Re: Work Plan Amendment for Soil Gas Sampling (Revised)
ERP Site No. E447036
Clinton South Parking Lot, 314 Clinton Street, Schenectady, NY
CTM Project No. 05.5551

On behalf of the City of Schenectady and Schenectady Metroplex Development Authority, C.T. Male Associates, P.C. (C.T. Male) previously submitted a Work Plan Amendment (March 16, 2007) associated with soil gas sampling activities to be completed at the 314 Clinton Street property (Site). This amendment has been revised to incorporate changes requested by the New York State Department of Environmental Conservation (NYSDEC) as noted in its April 20, 2007 correspondence. The specific scope of work presented herein was developed in accordance with the Remedial Investigation (RI) Work Plan prepared for the Site, and based on the findings of the recently completed RI, as presented in C.T. Male's report entitled, *Remedial Investigation Report, ERP Site #E447036, Clinton South Parking Lot, 314 Clinton Street, City of Schenectady, Schenectady County, New York*, dated January 2007.

PROPOSED SOIL GAS SAMPLING LOCATIONS

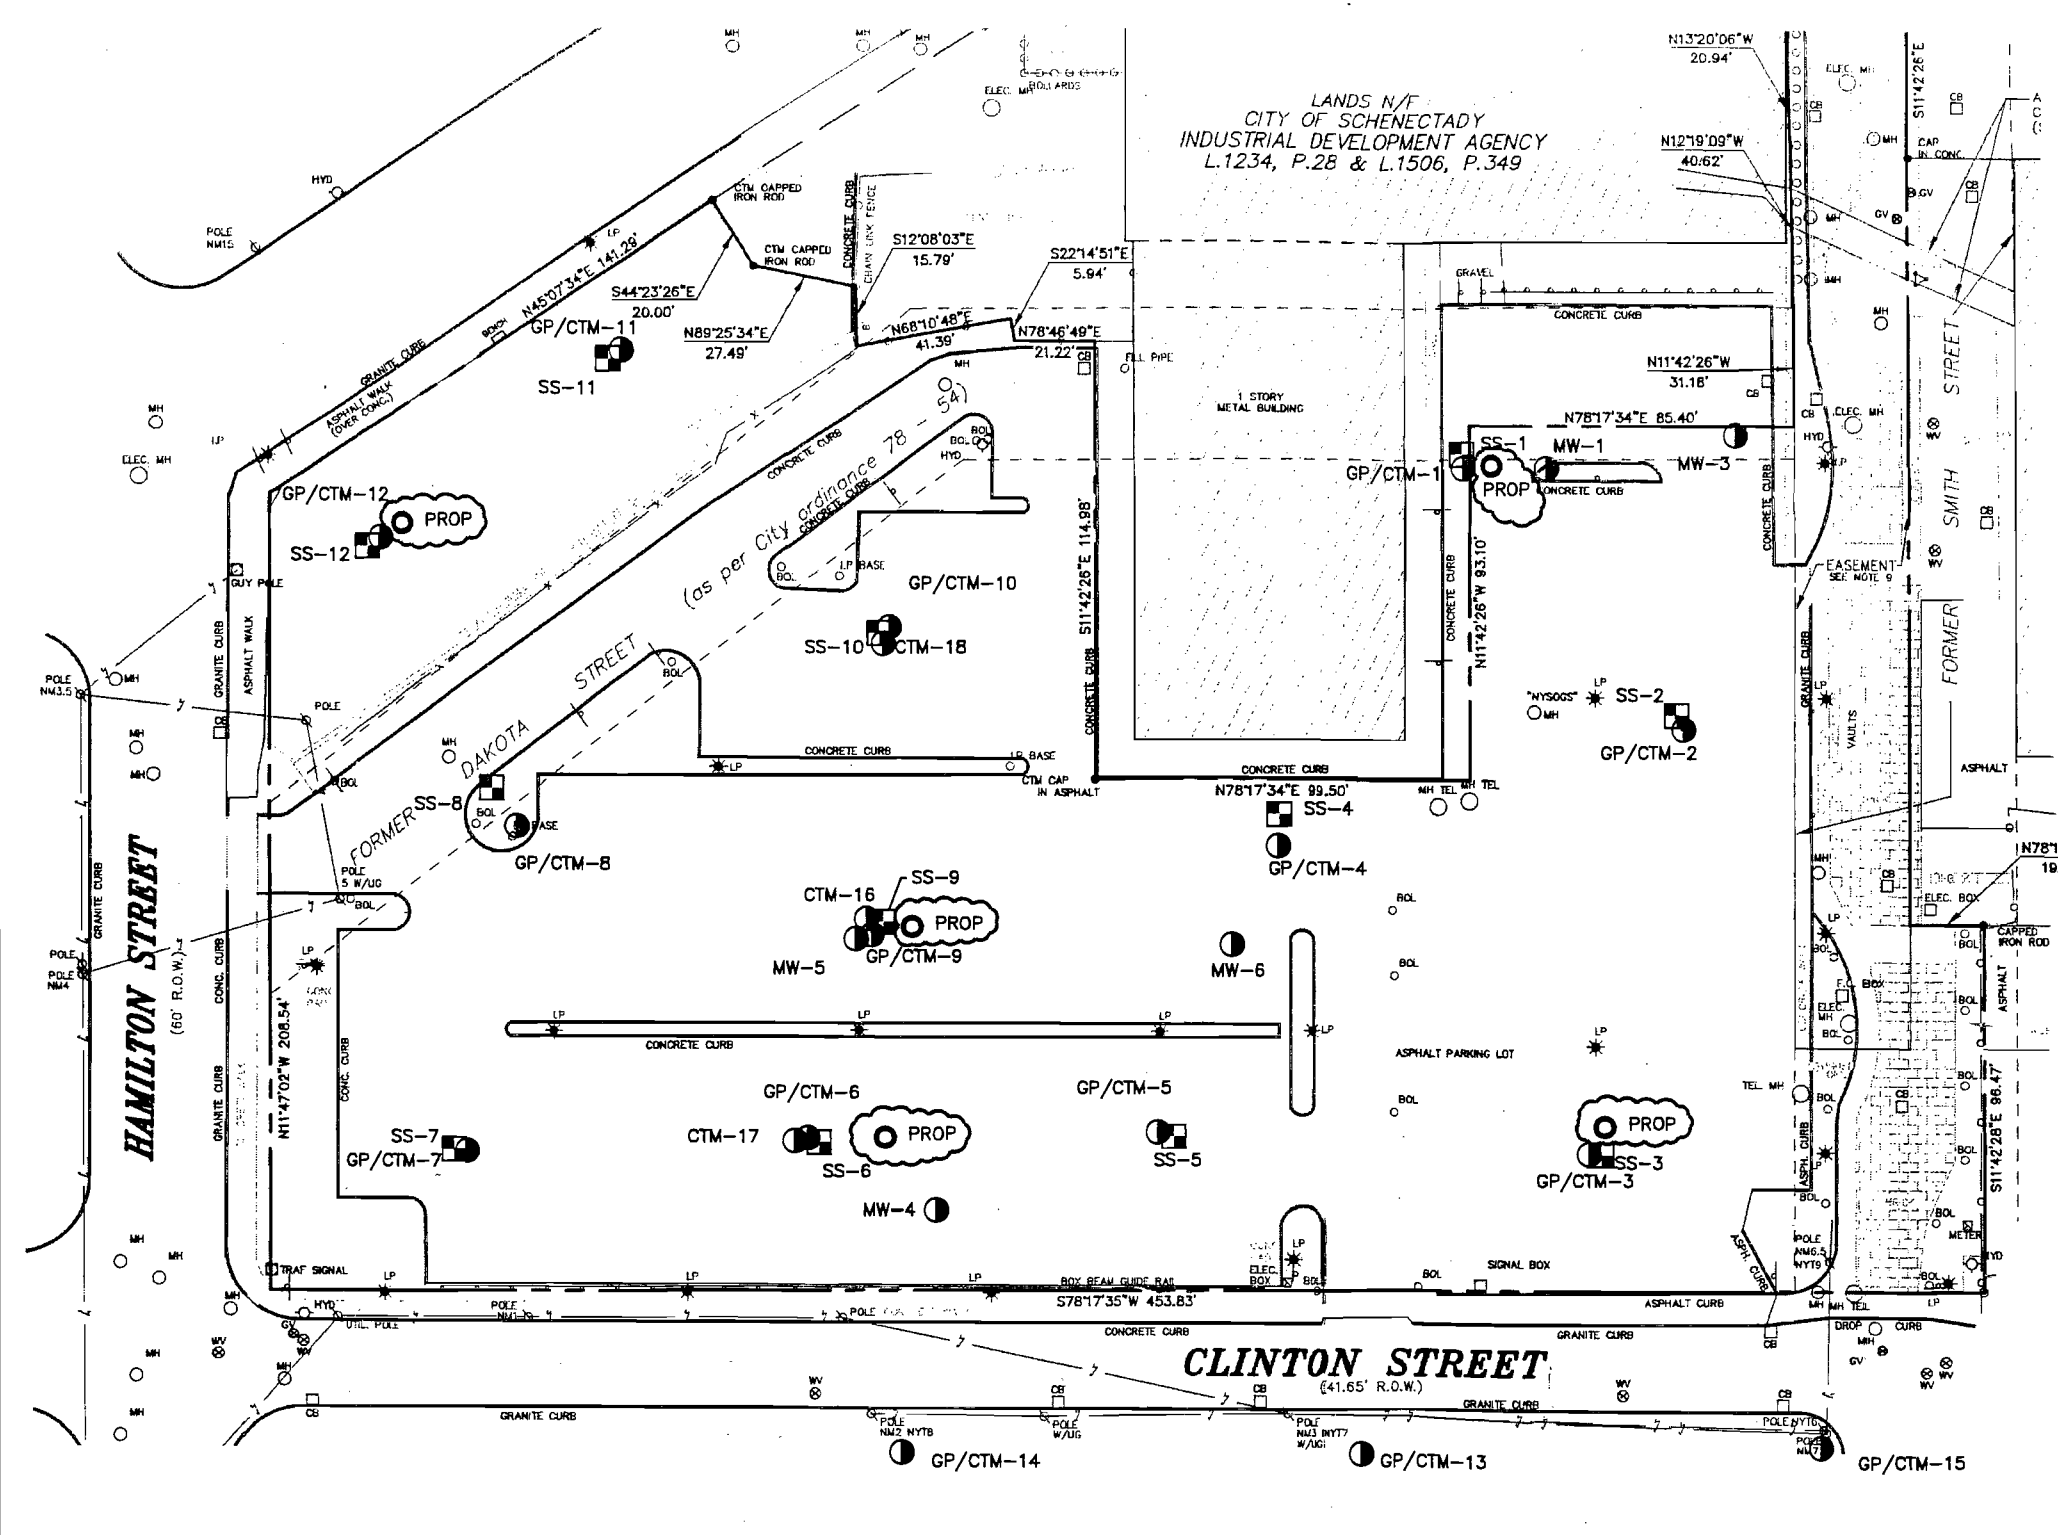
compounds were above the laboratory method detection limits, but below applicable regulatory Standards, Criteria and Guidance (SCG) levels. These compounds were identified in four areas of the Site: the northern portion, in the general area of the former gasoline filling station (SS-1, GP-1); the easternmost portion, near the intersection of Clinton Street and the pedestrian walkway (SS-3); the westernmost portion, near the intersection of Hamilton Street and Broadway (GP-12); and the central-southern portion, in the general area of the former dry cleaning operation (SS-9, GP-6). These areas will be the focus of the proposed soil gas sampling activities. Proposed soil gas sampling locations are shown on the attached figure.
